US 1/SR 4 Bridge Replacement Over Altamaha River, Overflow 1 and Williams Creek

BR000-0001-00(216), P.I. No. 0001216
Appling and Toombs Counties, Georgia

Value Engineering Study Report

February 2010

BRIDGE #3 (WILLIAMS CREEK)
PLAN & ELEVATION

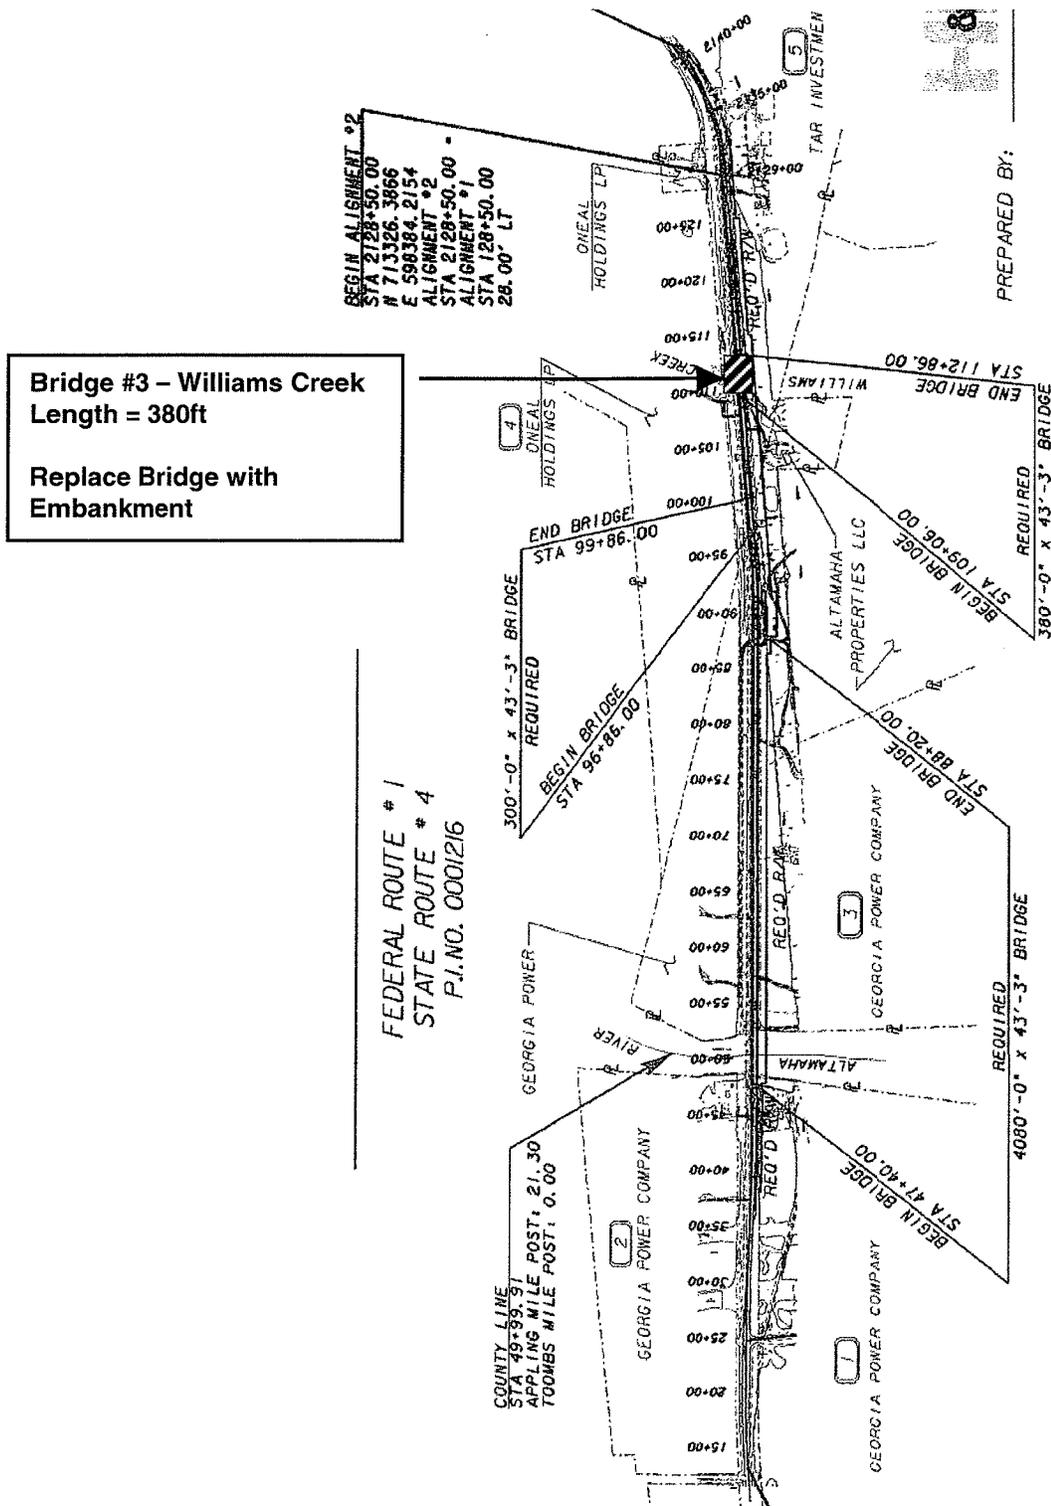
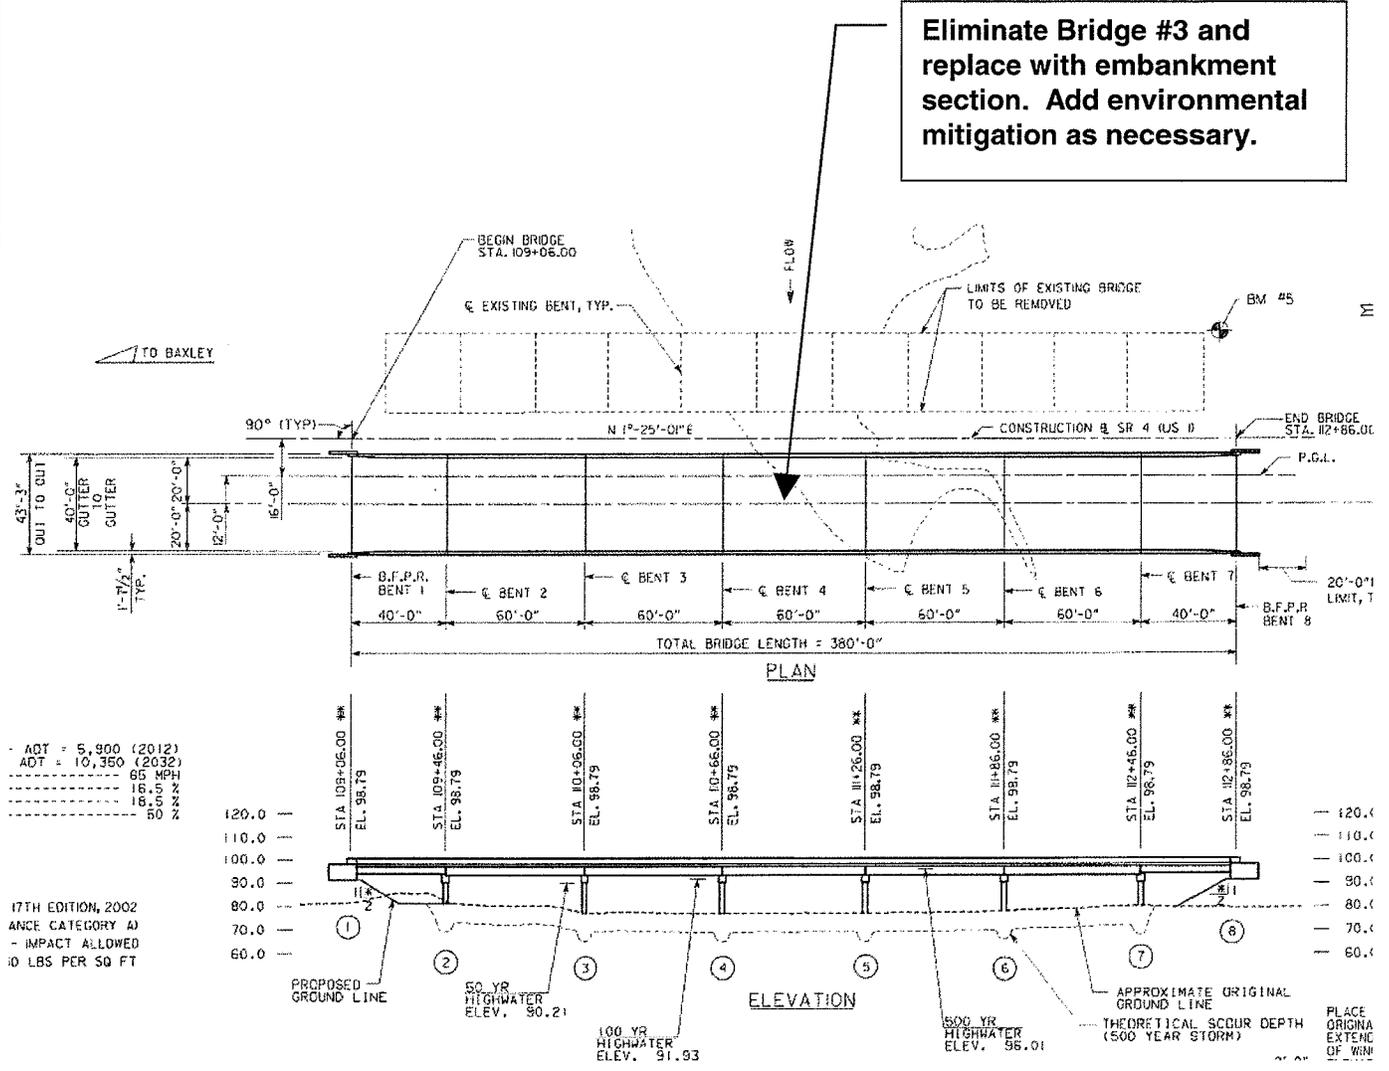
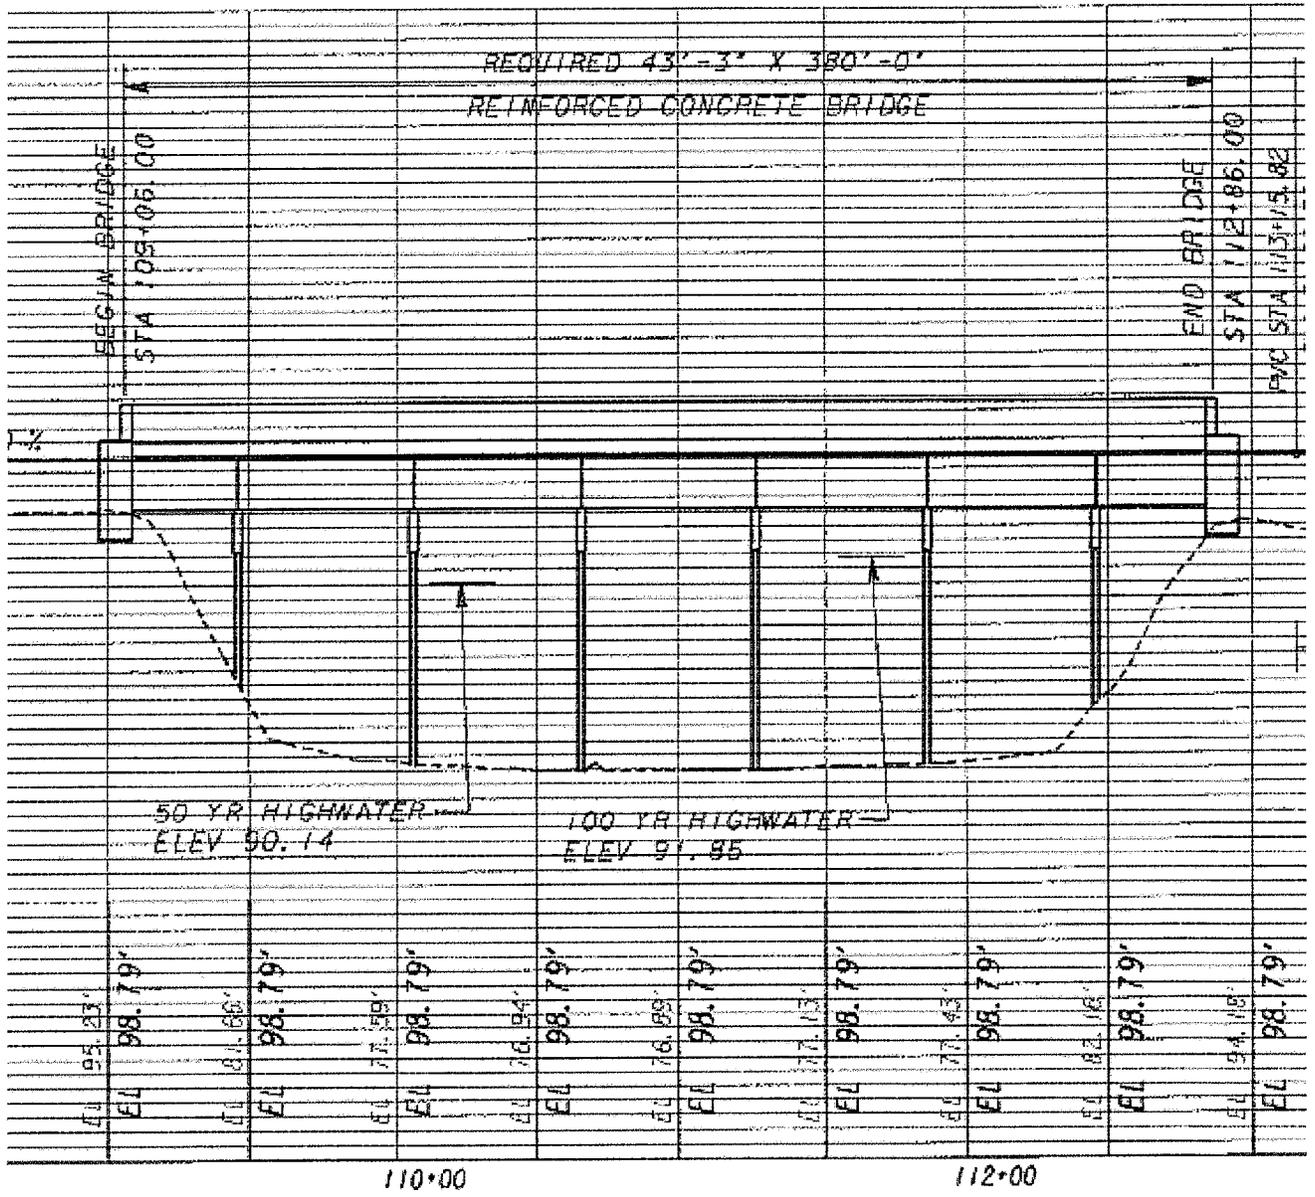
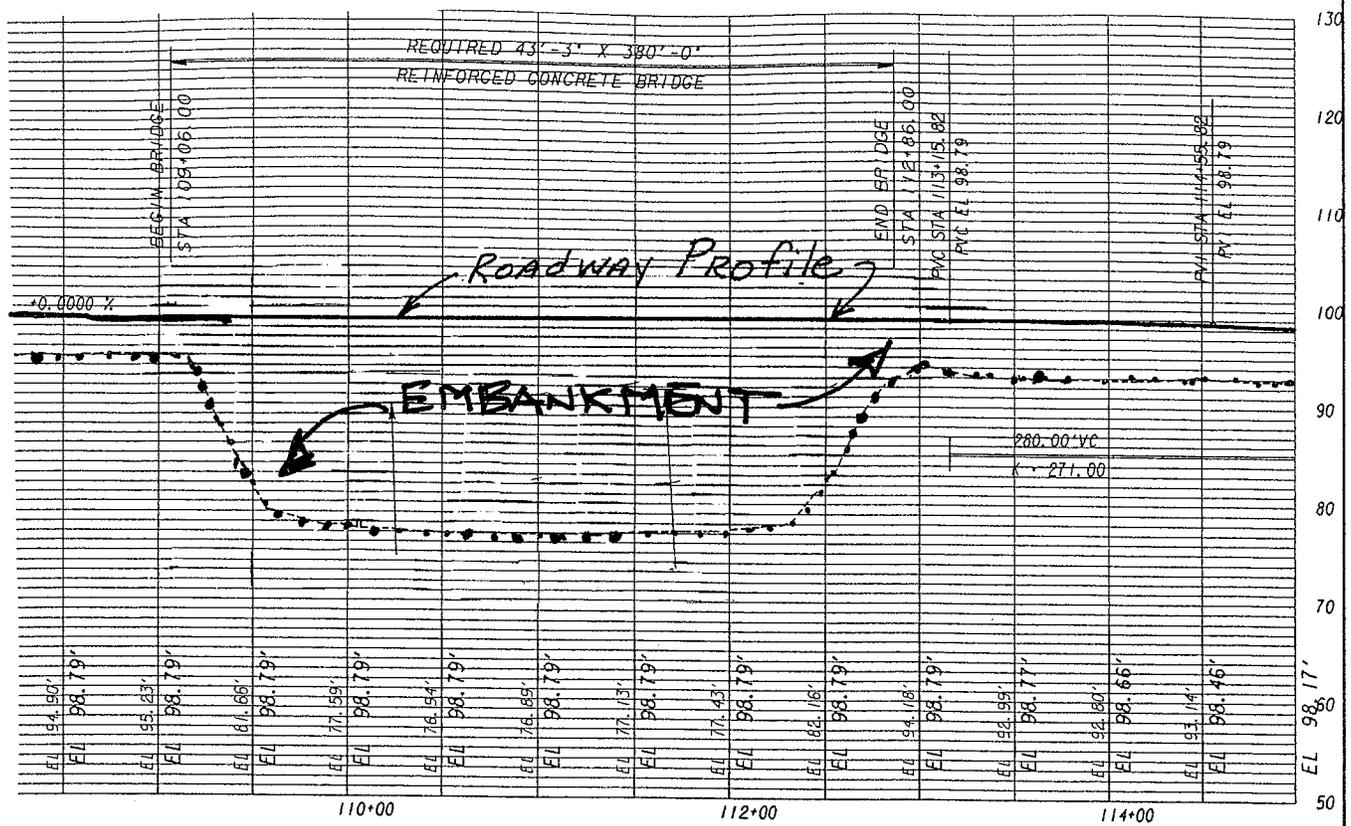
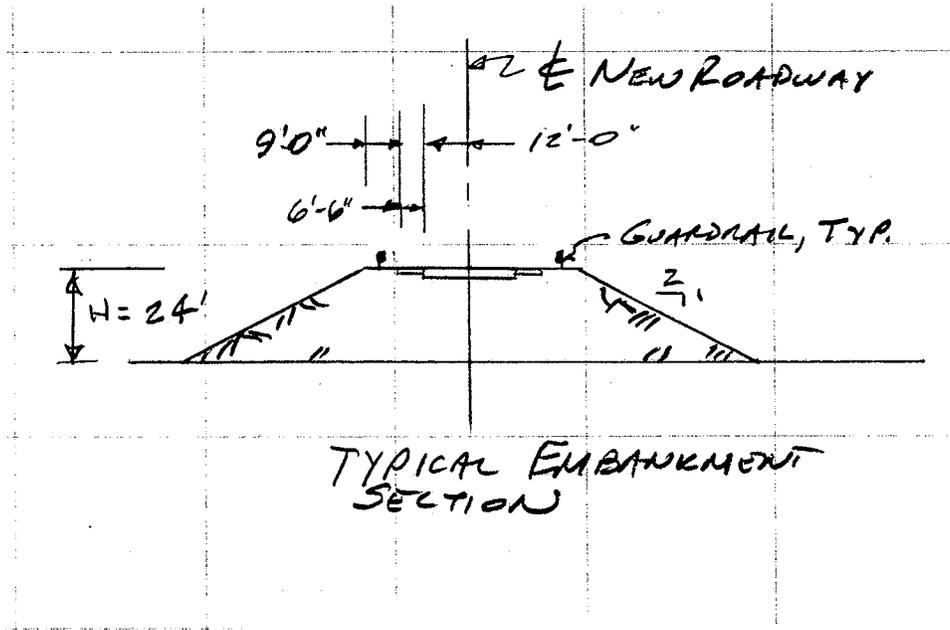
Alternative B3-4 presents a concept to replace Bridge #3 (Williams Creek) with a 380LF long embankment section for a net savings approaching \$1.2M. More than likely only one of the two bridges could be replaced with embankment, but either structure could be evaluated for backwater impacts to the overall Altamaha River floodway. The potential return on investment for the added hydraulic analysis could be substantial in both alternatives, but verification of scour velocities, backwater, and the potential need for guide banks requires a rigorous evaluation.

Eliminate Bridge #3 and replace with embankment section. Add environmental mitigation as necessary.
